Applicants: SLOWE et al.  
Appl. No. 09/956,971

**Amendments to the Drawings:**

The two attached sheets of drawings include changes to Figs. 4 and 6. These two sheets include, respectively, Figs. 4 and 6, and replace the corresponding two original sheets of drawings. In Fig. 4, Block 42 and in Fig. 6, Block 76, a spelling error has been corrected.

FIG. 4

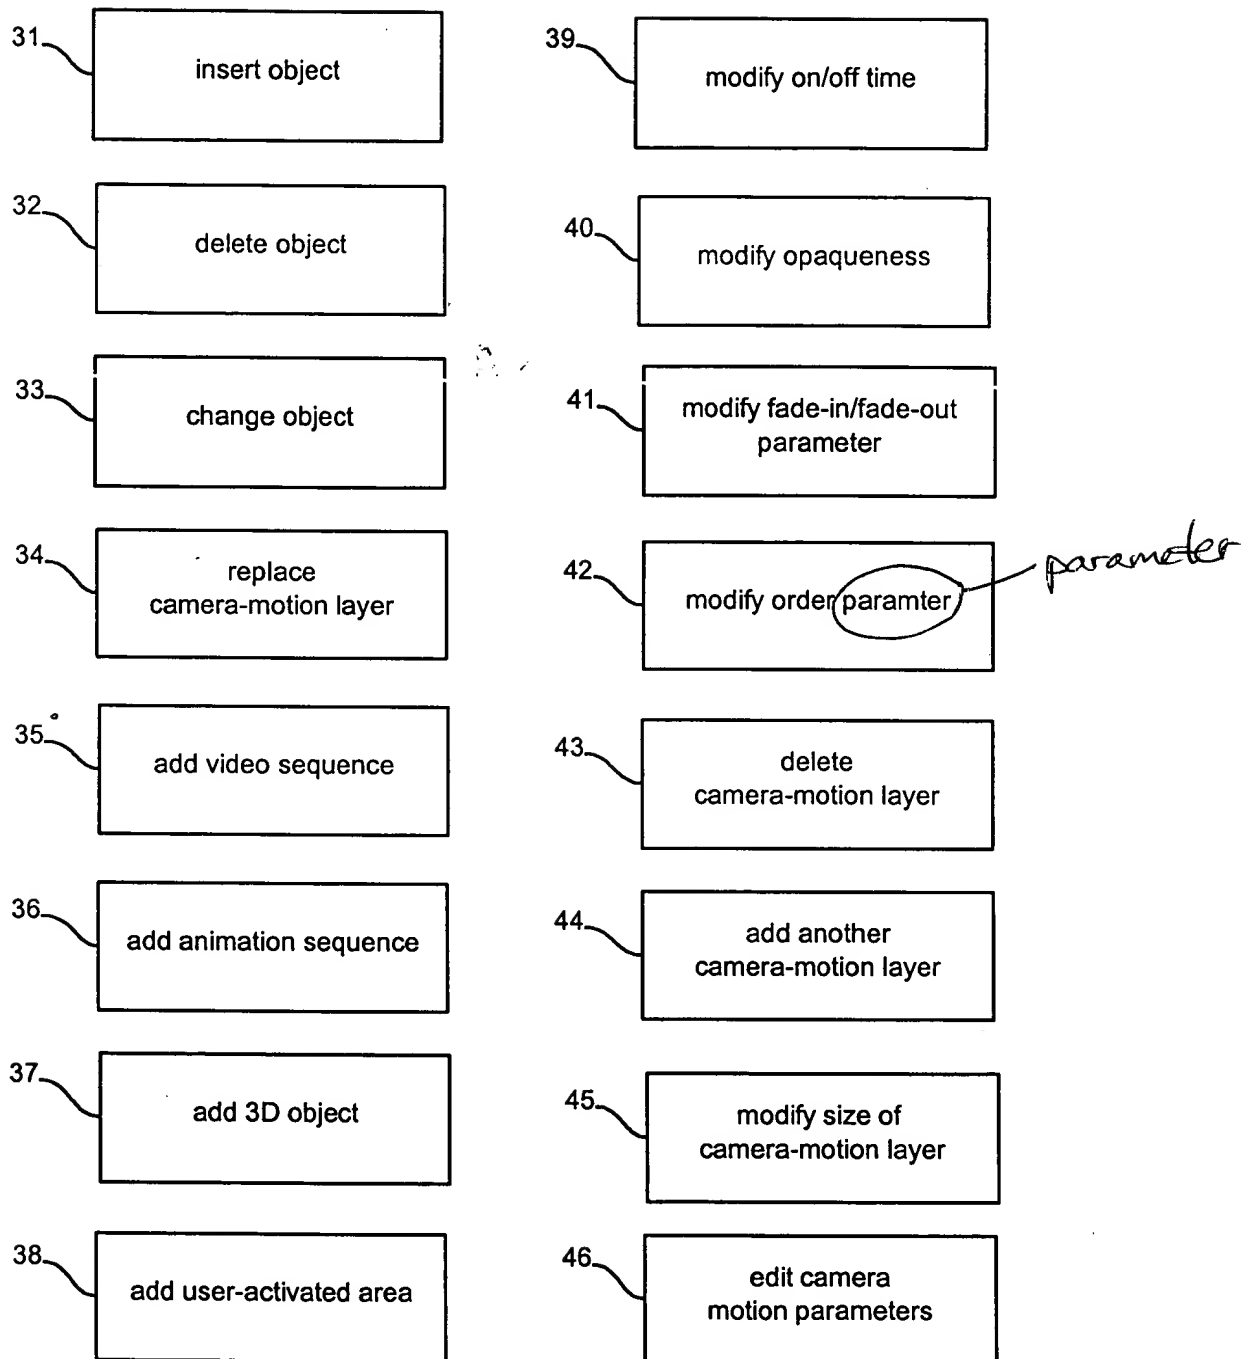
Figures 4 and 6 have been amended to correct misspellings (both of the word "parameters"), only one of which (the latter) was noted in the objection to the drawings at Page 2 of the Office Action.
